Cambridge Biomedical Campus Emerging Spatial Framework: Visual Commentary, October 30th 2023

Further to initial inputs given in late 2022, terra firma have been invited to comment on the emerging Spatial Framework.

With the further development of the Spatial Framework by Allies and Morrison, terra firma has been instructed to assess the visibility of the proposals, particularly from the Strategic Views.

Viewpoint 5 from SE

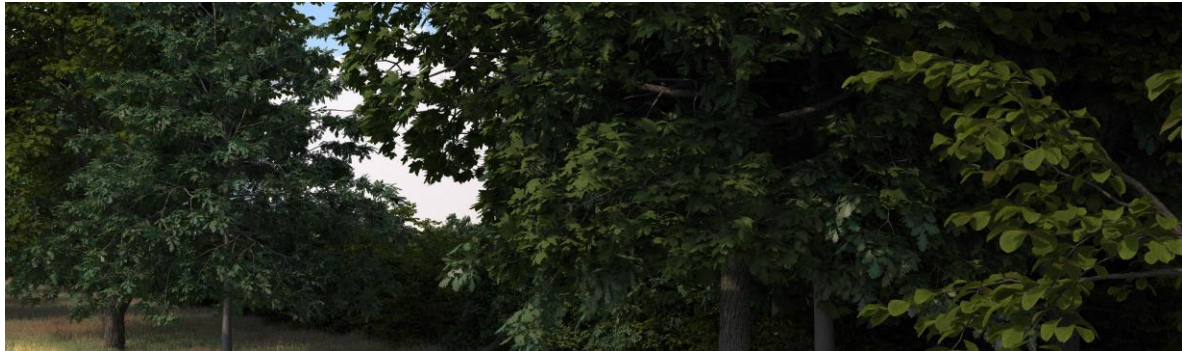
- From this elevated position, the Chalk Hills topography, city and fenland beyond are the dominant points of interest in the far-reaching and wide panoramic view. Within this context the Proposed Development is introducing change to a small area of the view composition, nevertheless an important one in the middle ground of view at the city's edge.

- The Addenbrooke's Hospital buildings introduce more height and mass within the built area but do not interrupt the horizon and views to the historic city core and landscape beyond.

- The proposed expansion land development replaces open field and extends the city toward the viewer, albeit somewhat contained by topography and existing woodland belts.

- The extension of built form to the south (on to the phase 3 and 4 land) is an opportunity to improve on the current high wall of built edge offered by the CBC. The massing orientation, stepping down in height and size from the previous phases, can be seen as a positive. Seen within the river valley landscape context and set against the rising backdrop, the smaller scale and variation in block elevations and roof profile is expected to introduce variety and a finer grain of detail, enhancing the aesthetic quality of the settlement edge.

- Development does not obscure visually important landscape features. The mature tree belts and wooded hills remain intact as does the rolling farmland foreground, with views of the city and fenlands beyond.

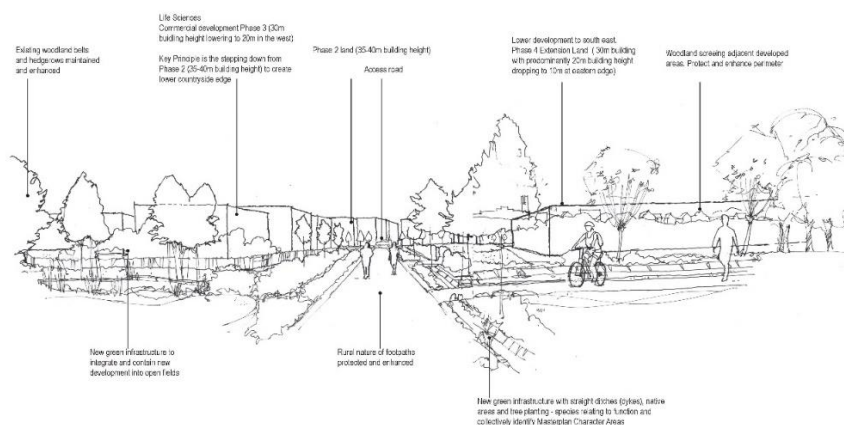
- Proposed Development is introducing large scale change in close proximity to the viewer.
- The hospital area increases in height, mass and the extent of horizon lost.

- The proposed extension land development replaces open field, obscures much of the horizon and extends the city toward the viewer, albeit somewhat contained by existing woodland belts.

- The extension of built form is an opportunity to improve on the current high wall of built edge offered by the CBC. The massing orientation, stepping down in height and size from the previous phases, can be seen as a positive but would be barely seen from this viewpoint. The importance of lowered roofline and well designed architectural detail with well integrated landscape will be an important factor in mitigation.

- The introduction of Green Infrastructure and planted open spaces within the public realm and providing new boundary woodlands to the new extended settlement edge, will assist in integrating (and from this viewpoint, potentially screening, in part) the built form into the landscape.

- Considering the balance between improvement to settlement edge treatment with the incursion into countryside, reduces adverse visual effects and improves on the assessment from construction stage. New boundary planting, once established, could almost entirely screen the view from the road at this point but some account should be taken of filtered winter views and the open view at the entrance to and once on the public footpath on the development's side of the new planting. Our sketch from our initial work last year indicated this:
